Sydney Olympic Park New High School

Architectural Response to SDRP Report

Undercroft entry

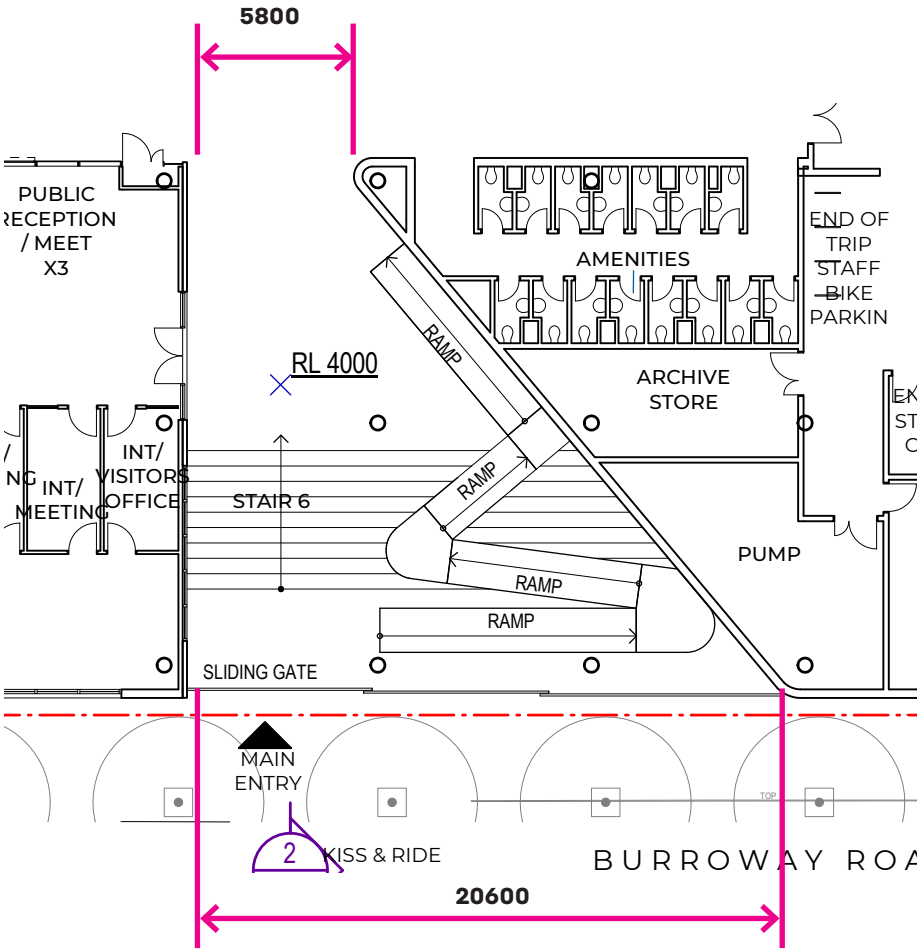
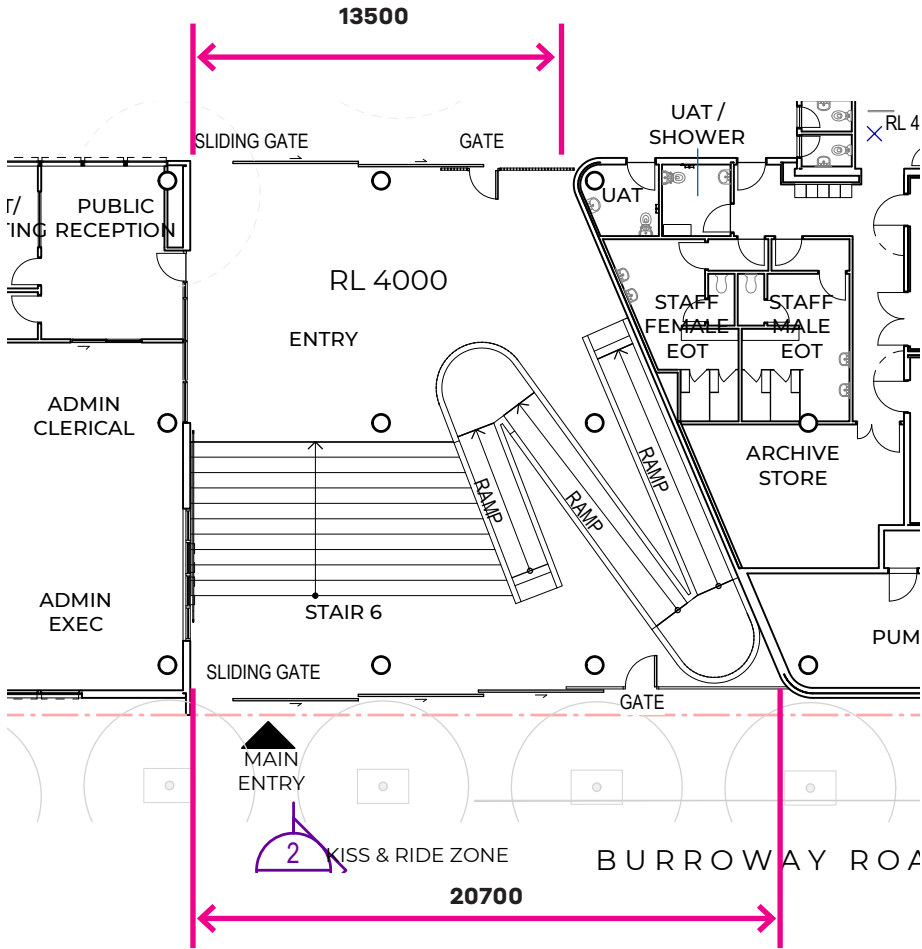
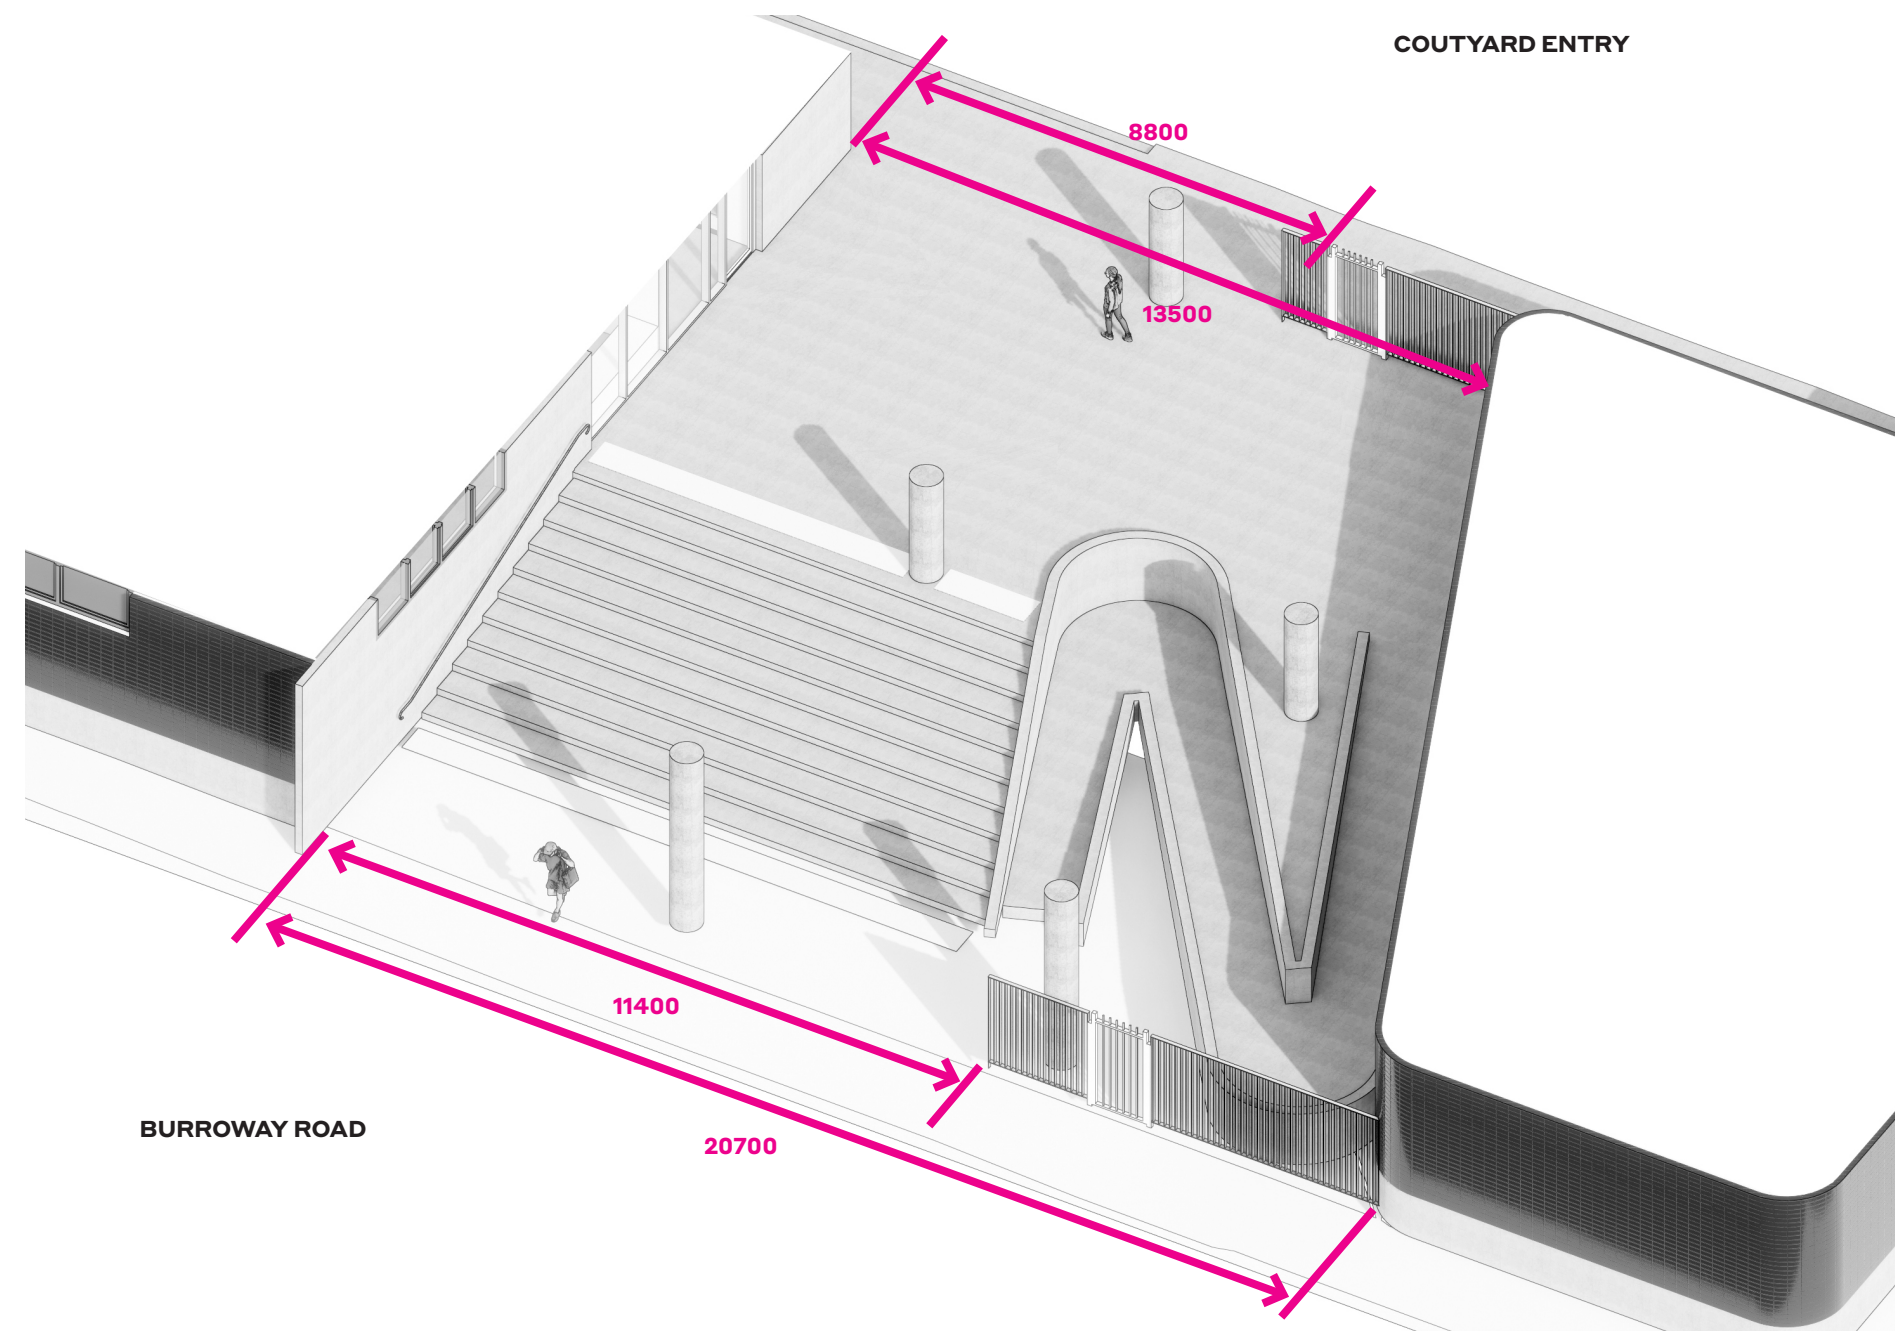
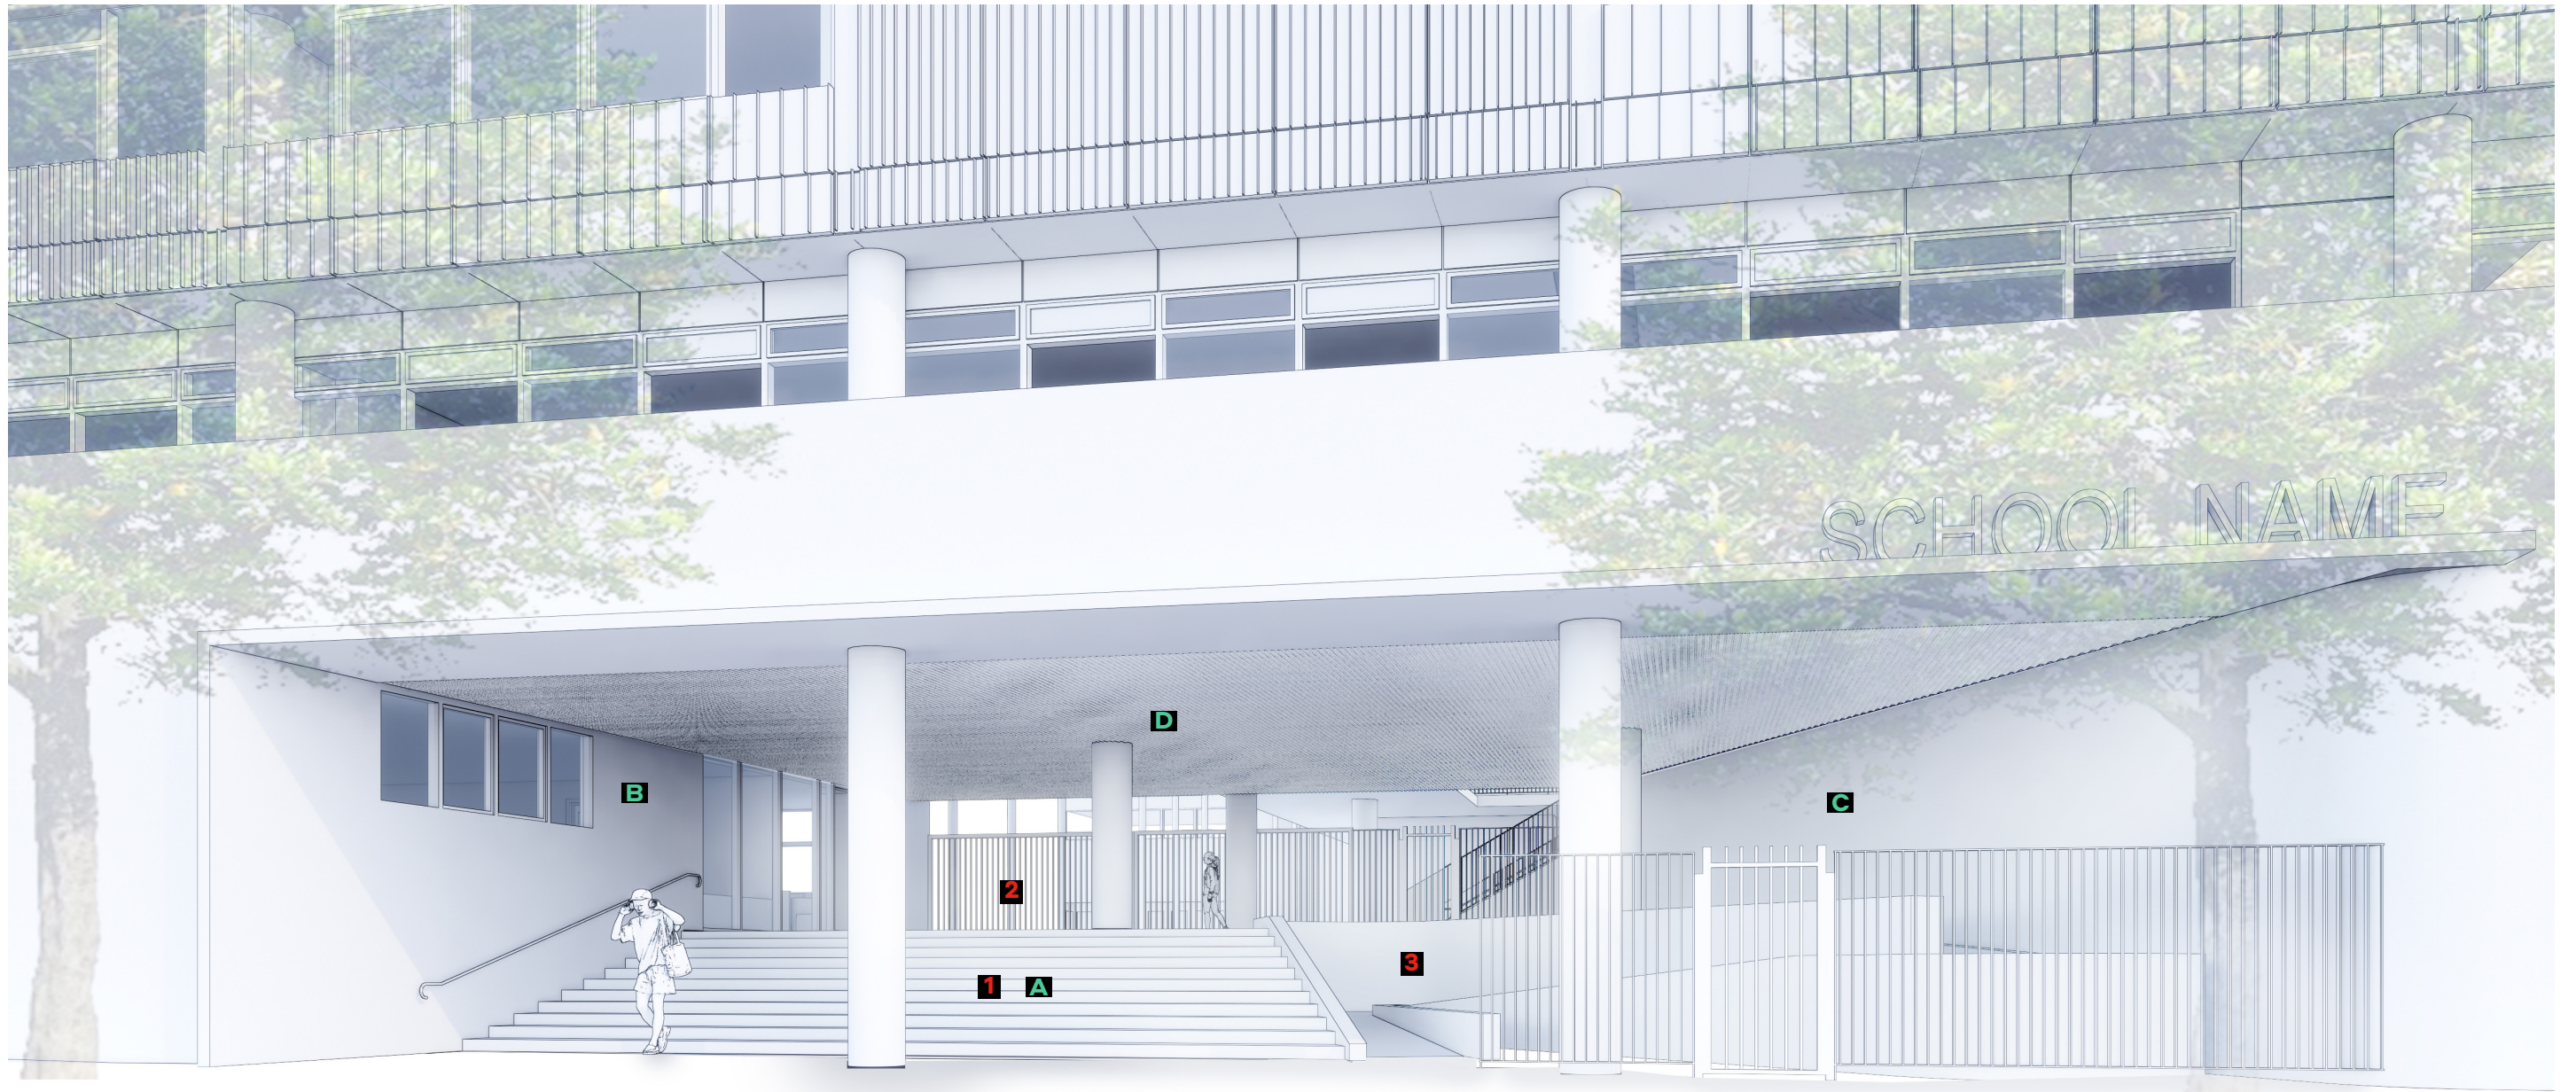
Comment: Undercroft entry – Illustrate this area in greater detail to demonstrate how the height and width constraints have been mitigated through lighting, materiality, surface treatments and other strategies.

The school's main entry from Burroway Rd (the undercroft entry) has been reconfigured by widening the opening into the school courtyard. Previously, the opening on the northern side of the undercroft was 5.86m in width; this opening is 13.35m in width. This increase ensures that the entrance will be capable of managing the volume of students that move through the space as they arrive at and depart from the school. It dramatically enhances a sense of welcome and openness from Burroway Rd, bringing substantially more daylight in from a northern aspect. It also provides new glimpses of the staircase rising up to level one.

The arrangement of the stair and ramp in the undercroft has been simplified to improve the flow of students through the undercroft. The ramp is now located on the eastern edge of the space, taking up a more compact footprint than previously. A wide stair inhabits the western side of the undercroft, creating a generous, axial thoroughfare that is at minimum 9m in width.

Footpath along Burroway Rd T-junction

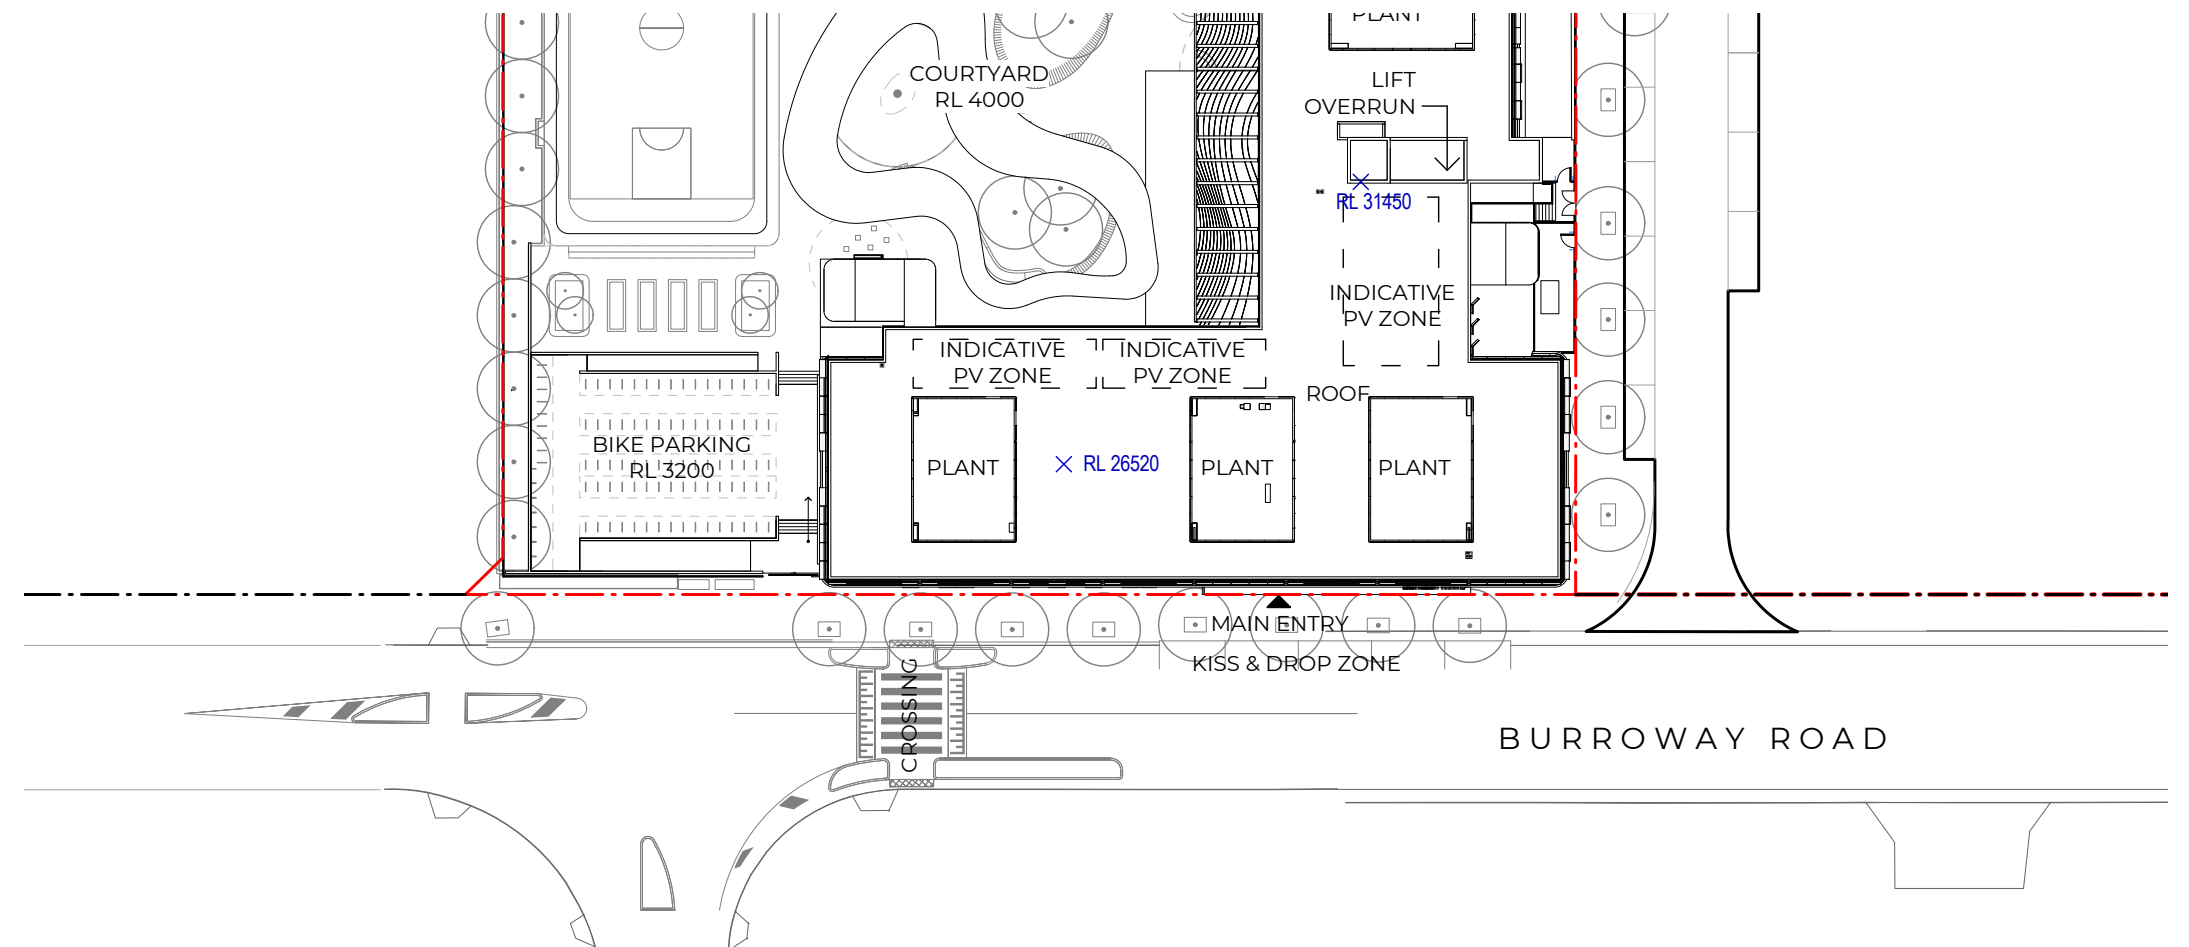
Comment: Footpath width – The footpath at the roundabout on Burroway Road is too narrow and poses a safety risk. Confirm resolution of this area to enable shared access for cyclists and pedestrians during peak periods.

The roundabout at the intersection of Burroway Rd and Wentworth Place will be replaced by a give-way T-intersection. The footpath will be infilled at the intersection, creating a continuous footpath approximately 3-4m in width, matching the line of existing kerbs to the east and west of the intersection.
